Product Change Notice (PCN)

PCN Number: **PCN-0454736R-01**

Product(s) Affected: *SJ2-2577X-SMT-TR Series.*

SJ2-25774B-SMT-TR, SJ2-25774A-SMT-TR & SJ2-25773B-SMT-TR

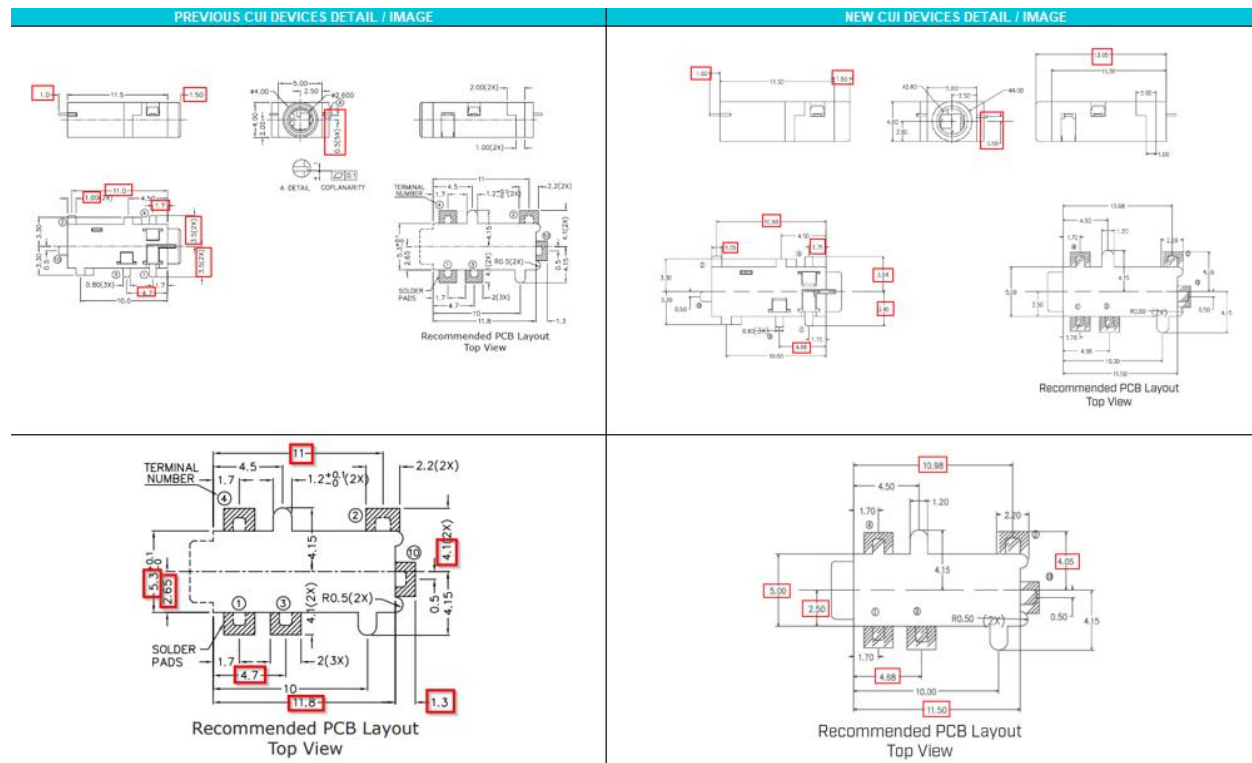
Description of Change: *Minor Housing and footprint differences. Material Change on the housing and terminals. See image Below*

PREVIOUS CUI DEVICES DETAIL / IMAGE		
	MATERIAL	PLATING
terminal 1	copper alloy	silver
terminal 2	copper alloy	silver
terminal 3	copper alloy	silver
terminal 4	copper alloy	silver
terminal 10	brass	silver
plastic	PA10T

NEW CUI DEVICES DETAIL / IMAGE		
DESCRIPTION	MATERIAL	PLATING/COLOR
terminal 1	brass	silver
terminal 2	brass	silver
terminal 3	brass	silver
terminal 4	brass	silver
terminal 10	brass	silver
housing	PA10T (UL94V-0)	black

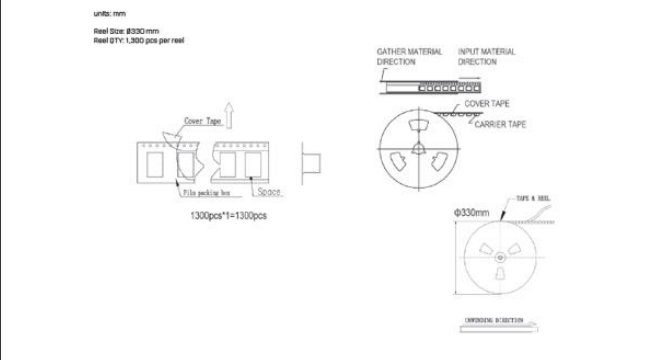
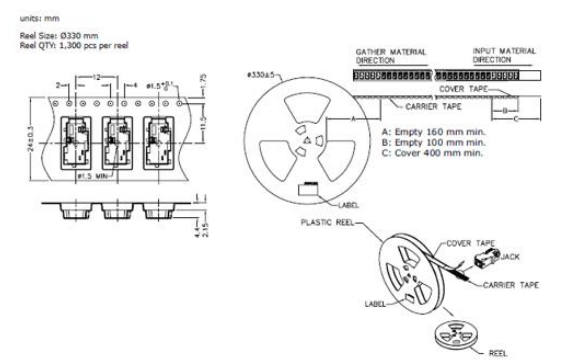
SOLDERABILITY

parameter	conditions/description	min	typ	max	units
reflow storage	at relative humidity $\leq 50\%$			40	$^{\circ}\text{C}$
reflow soldering ¹	see reflow profile	255	260	265	$^{\circ}\text{C}$
drying conditions ²	parts in reel: bake at 40 $^{\circ}\text{C} \pm 5^{\circ}\text{C}$ for 72 hours parts removed from reel: bake at 40 $^{\circ}\text{C} \pm 5^{\circ}\text{C}$ for 10 hours

Note:
 1. Must reflow solder within 72 hours from opening vacuum packaging at a temperature $\pm 20^{\circ}\text{C}$ & relative humidity $\leq 60\%$.
 2. When exceeding four lifts by >72 hours.

SOLDERABILITY

parameter	conditions/description	min	typ	max	units
reflow storage	10-30 $^{\circ}\text{C}$, $\leq 50\%$ humidity				$^{\circ}\text{C}$
reflow soldering ¹	see reflow profile	255	260		$^{\circ}\text{C}$
drying conditions ²	parts in reel: bake at 110 $^{\circ}\text{C}$ for 4 hours parts removed from reel: bake at 110 $^{\circ}\text{C}$ for 4 hours

Note:
 1. CUI Devices recommends to solder within 72 hours from opening vacuum packaging at a temperature $\pm 20^{\circ}\text{C}$ & relative humidity $\leq 60\%$.
 2. When exceeding four lifts by >72 hours.

* Time 25°C to Peak Temp. --- 8 Minutes Max.
 * Time within 5°C of Actual Peak Temp. --- 10-40 Seconds
